**Final
2010 Five-Year Review Report
for
Rocky Mountain Arsenal
Commerce City
Adams County, Colorado**

Review Period: April 1, 2005–March 31, 2010

September 2011

Tetra Tech EC, Inc

Figure 2 **Groundwater flow system in hummocky terrain (after Freeze, 1972).**

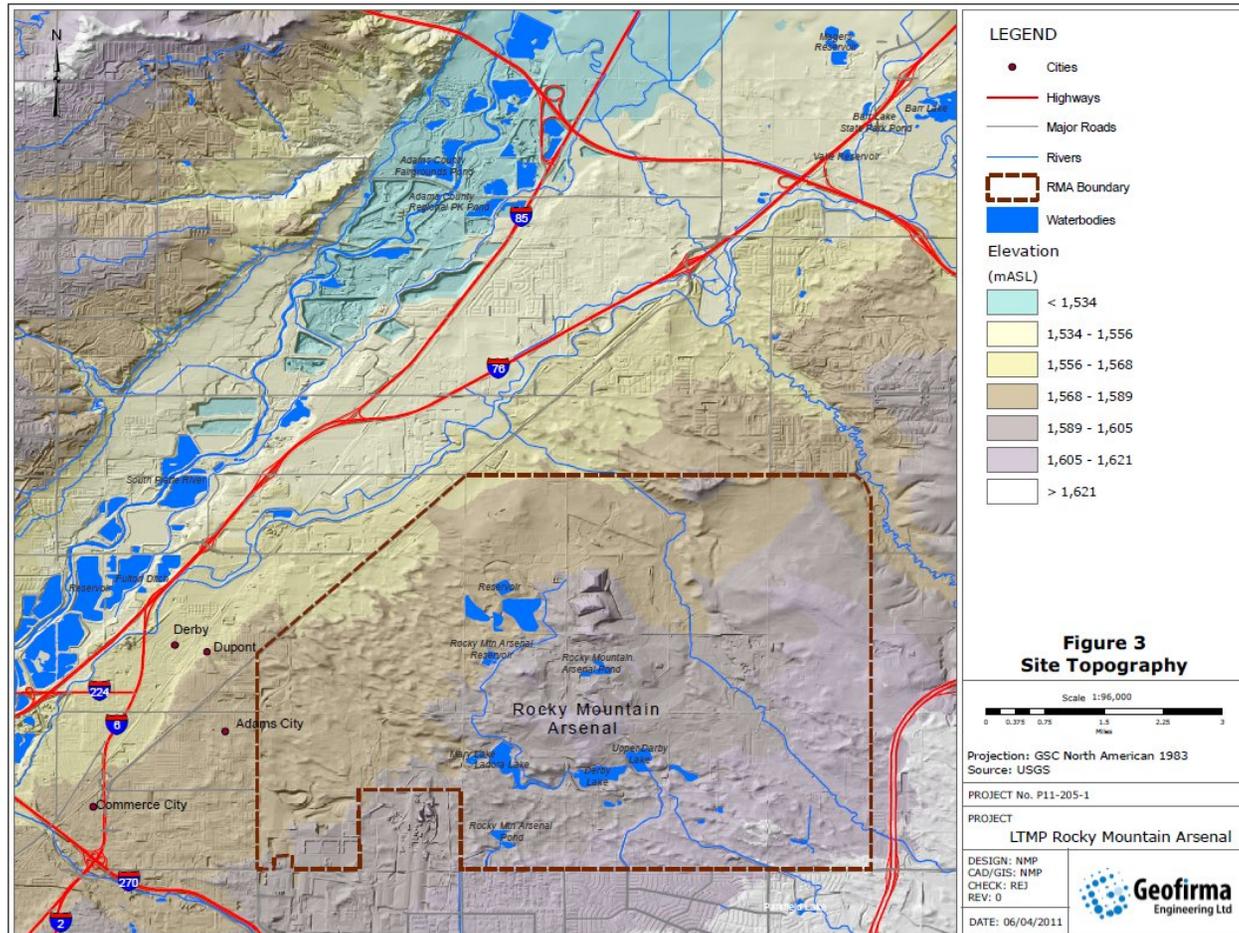
Figure 2 shows a typical groundwater flow system in hummocky terrain, similar to the RMA. The recharge areas are identifiable by the decrease in head with depth and occupy the topographic high ground; groundwater flow in these areas is vertically downward. Most land surface in any flow system is part of the recharge area. The discharge area is confined to the topographic low areas where the hydraulic heads increase with depth. Such groundwater flow patterns are well recognized in the hydrogeological literature; Toth (2010) has recently presented a very substantial monograph of gravitationally-driven groundwater flow systems based upon his own work and that of Freeze (Freeze and Cherry, 1979) and several generations of younger hydrogeologists.

With this background in mind, it is possible to see the whole of the RMA as forming a recharge area of a flow system that discharges in the South Platte Valley. Figure 3 presents a Digital Elevation Model produced from US Geological Survey data showing the topography that governs the RMA flow system. Table 6.1-7 of the Plan lists hydraulic head data and hydraulic gradient directions for monitoring wells that indicate downward flow and referred to in section 6.1.3.1 as “*adjacent wells*”. This data is therefore consistent with our conceptual model of the RMA flow system in which the RMA is a recharge area. Even in the far NW corner of the RMA, i.e., Section 23, there is a downward gradient between the unconfined and the confined Denver Formation (fm.), i.e., $dh/dL = 0.93$ in well pair 23185-23187 and $= 0.99$ in well pair 23191-23193. A vertical hydraulic gradient approaching unity is to be expected in a continuously saturated flow system (Hart et al., 2008), in this case the Denver fm. Such a large gradient can be expected to produce a deep flow pattern with streamlines traveling to considerable depths. It is on the basis of this flow system that underflow through the Denver fm. may occur must be judged as a distinct possibility.

The conceptual groundwater flow system discussed in the GEI Report (Figure 2) only shows the direction of groundwater flow and does not include travel time or flow volume components. As discussed in the RVO response for the Confined Flow System, a downward hydraulic gradient only indicates the potential for downward migration. The extremely low vertical hydraulic conductivity in the confined Denver Formation would cause any downward migration to be extremely slow with extremely small volumes. As discussed previously, there is no evidence for the bedding plane fractures in the Denver Formation at RMA that the GEI Report indicates may be causing underflow of contaminants. Additionally, there is no evidence that underflow in the Denver Formation is causing off-post migration of contaminants based on water-quality monitoring data. For any conceptual model to be viable, it must be validated by site-specific data. No site-specific data supports the conceptual groundwater flow system discussed in the GEI Report.

Figure 4 Dakota sandstone, Dinosaur Ridge, Colorado, showing bedding-plane fractures

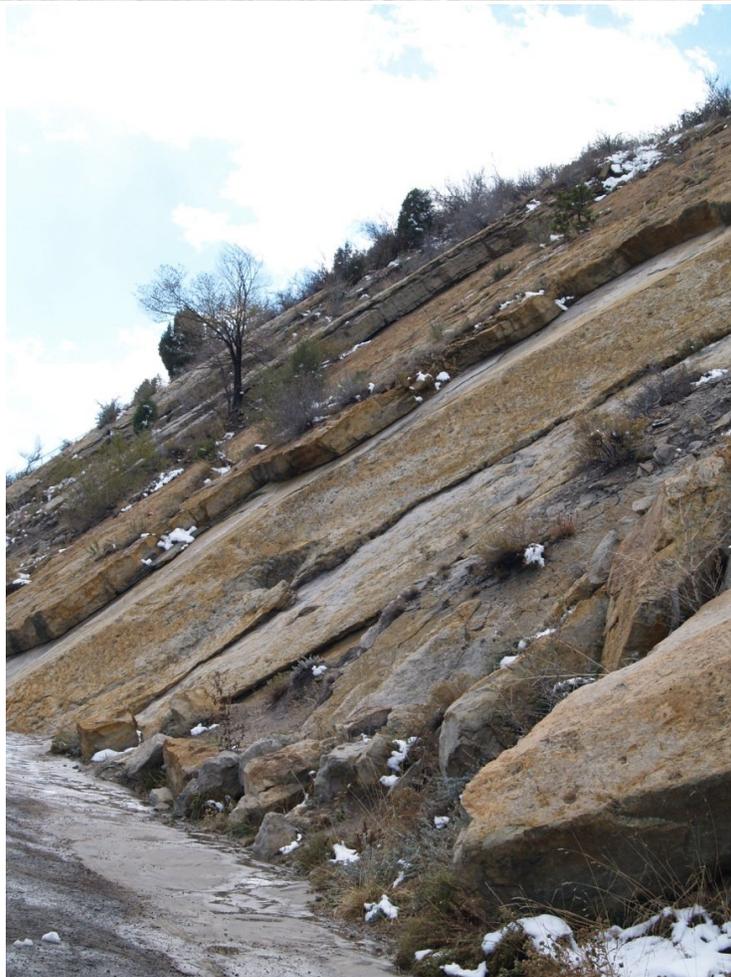
F and the North Boundary areas. This contamination is presumably still on-post, however it is the responsibility of RMA to demonstrate that it is not migrating off-post. This raises the issue of the nature of groundwater flow in the Confined Flow System (CFS) of the Denver fm, which is shown in outcrop in Figure 4. In fractured sedimentary rocks, flow is mainly through the fractures themselves and the Denver fm is no exception. This conclusion is supported by the effective porosity of 0.001 (0.1%) reported in the tracer test mentioned in Appendix A of the Plan (page 23 of 26), which was presumably conducted in the unconfined Denver fm. Such low effective porosities are exactly what should be expected from tracer tests in fractured sedimentary bedrock (e.g., Freeze and Cherry, 1979, pp. 408-409, Robinson, 1995; Lapcevic et al., 1999; Meigs and Beauheim, 2001; Becker and Shapiro, 2003) that transmit contamination by channelized flow (see Becker and Shapiro, 2003 and references therein). While the massive sandstone layers do transmit groundwater, they are not necessarily the principal pathways through which contamination migrates. Even Walker (1961, p.491) acknowledged that the confined Denver fm could have become contaminated through improperly plugged and abandoned wells, an admission that long preceded the realization by hydrogeologists that ‘confinement’ deduced from aquifer tests did not mean that the confining layers are necessarily free of fractures.

The RMA monitoring wells in the confined flow system of the Denver fm are long screened wells, i.e., ≥ 5 ft screen lengths, that will result in dilution of contamination due to mixing of zones of contaminated and uncontaminated groundwater. It also appears that well screens were preferentially set across the sandstone layers rather than being distributed across bedding planes (see Figure 5) throughout the well for example, (see Figures 4-3, 4-6 and 4-9 in the NBCS Addendum to the 2007 Five-Year Summary Report, Volume 1). This suggests that those responsible for establishing the monitoring well network anticipated that contaminant migration would be by intergranular flow through the sandstones themselves rather than fracture flow along bedding planes. The tracer test cited above argues against this conclusion. Figure 6 shows the distribution of hydraulic conductivity and flow in a sandstone aquifer in Wisconsin and a similar pattern should be expected in the Denver fm.

The highly indurated Dakota sandstone shown in Figure 4 in the GEI Report is approximately 8,400 feet deeper than the base of the Denver Formation at RMA (based on the RMA Deep Disposal Well log). The Dakota sandstone would behave as a brittle unit during structural deformation and be more prone to bedding plane fracturing. Additionally, the Dakota sandstone at Dinosaur Ridge, which is also called the Dakota Hogback, is located at the steeply dipping western flank of the Denver Basin, which borders the Colorado Front Range. The dip of the Dakota sandstone in the GEI Report example appears to be 45 degrees or greater. Thus, the Dakota sandstone has undergone significant structural deformation, consistent with the formation of bedding plane fractures. Thus, the Dakota sandstone example in the GEI Report is not relevant to the Denver Formation at RMA.

Figure 7 Monitoring well network north of RMA (Figure 6.2-1, LTMP). The areas enclosed in boxes are identified as “operational areas” and contain the OGITS extraction wells (unnumbered dots) as well as numbered upgradient and downgradient monitoring wells used to assess performance.

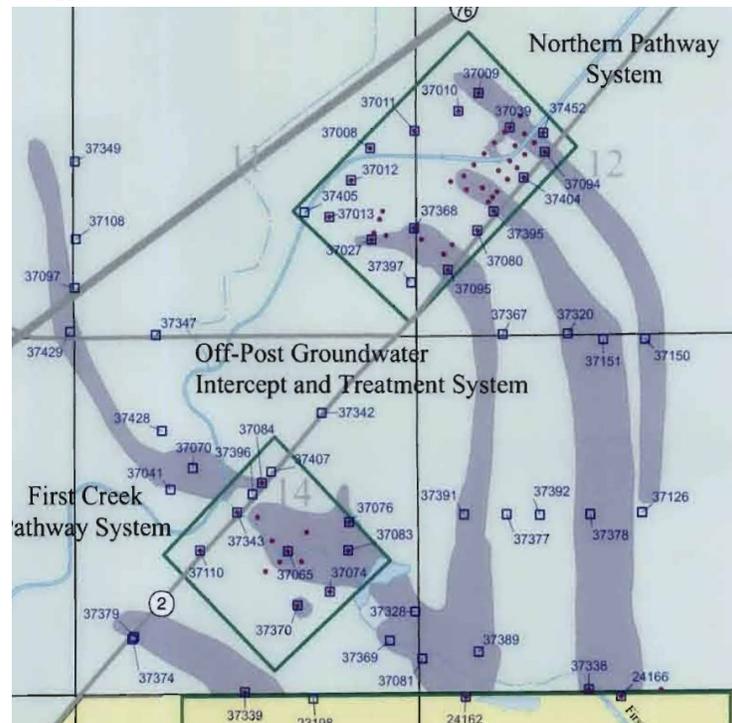
It is noteworthy that the OGITS is designed solely for the remediation of alluvial groundwater contamination with no provision made for removal of contamination from the Denver fm, either unconfined or confined systems. This is presumably due to RMA’s belief that “*Lateral migration of contaminants that have been detected in the CFS is limited and will occur at very slow rates*” (TtEC and URS, 2010); presumably RMA believes that the same situation applies to the unconfined Denver fm groundwaters.

recommended that annual sampling and analysis be conducted at all 58 exceedance monitoring wells – i.e., those shown in Figure 7.

Figure 8 An example of a fence of multi-level monitoring wells that provide a meaningful estimate of contaminant mass flux (from Einarson, 2006)

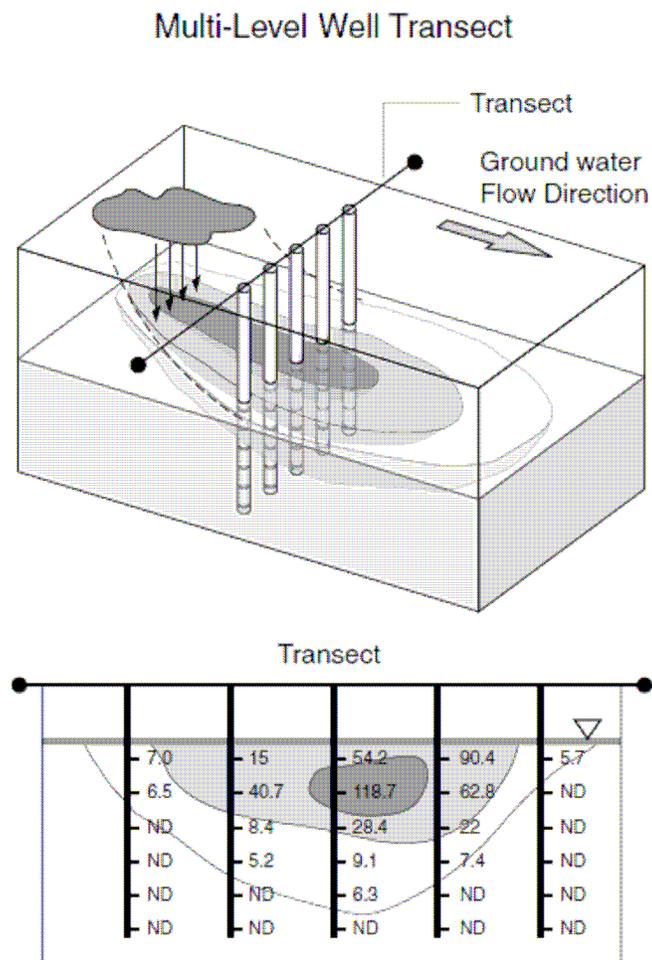
The means for conducting mass flux estimates are now well established in the scientific literature, e.g., Amerson and Johnson (2003), Guilbeault et al. (2005) and Brooks et al. (2008). They are estimated with transects or 'fences' of multilevel monitoring wells not sparsely distributed single-screen wells. Figure 8 shows an example of one such transect that will provide high resolution contaminant data. Furthermore, measurements of contaminant concentrations from extraction wells result in substantial dilution of the contaminant (Jackson and Mariner, 1995) that will affect the accuracy of the mass estimate in comparison with that from a monitoring well that will not be under pumping conditions. Therefore, RMA proposes two different kinds of estimates, one from a pumping well and the other from a non-pumping well, which estimates cannot yield values that are quantitatively comparable. Furthermore, each of these estimates will have very large error bars – so large that the comparison will be meaningless. For these reasons, mass flux estimates of contaminants are now computed by transects of multilevel monitoring wells and compared on that basis.

1. A multilevel transect upgradient of the extraction wells, e.g., a network of at least five (5) multilevel wells along Highway 2 for the Northern Pathway System, one each beside the five exceedance wells shown in Figure 7, and another five (5) upgradient of the First Creek Pathway System;

2. A multilevel transect downgradient of the extraction wells, e.g., a network of at least six (6) multilevel wells, one each beside the six exceedance monitoring wells shown in Figure 7, and another five along Highway 2 downgradient of the First Creek Pathway System;
3. Spatially distributed estimates of contaminant concentration, hydraulic conductivity, hydraulic head and gradient for each zone created by this network of multilevel wells so that a grid can be developed for each transect allowing meaningful Darcy Law estimates of contaminant mass flux.

Multi-level plume-transect monitoring has been conducted at RMA. For example, cone penetration testing (CPT) and multi-level sampling was conducted at selected sites to evaluate plumes in three dimensions similar to that shown in Figure 8 in the GEI Report. Additionally,
